UNITED STATES PATENT AND TRADEMARK OFFICE

Office Action Summary	Application No. 10/560,879	Applicant(s) ZERGIEBEL, EARL M.	
	Examiner Alexis M. Wistermayer	Art Unit 3733

DETAILED ACTION

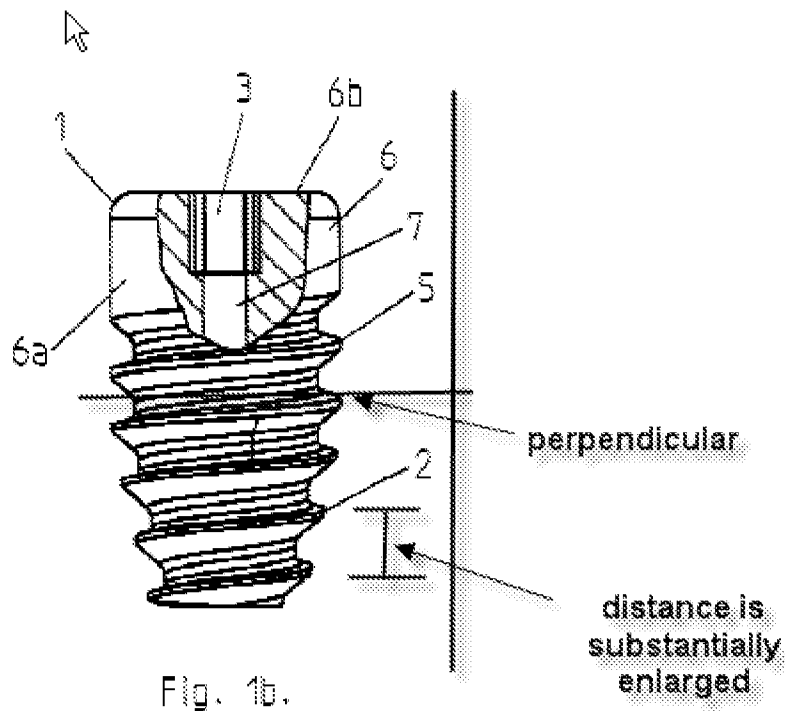
Regarding Claims 7 and 8: Sanders et al. teach a fastener where the land of the thread is substantially perpendicular to the longitudinal axis and where a distance of the thread is substantially enlarged (please see drawing below).
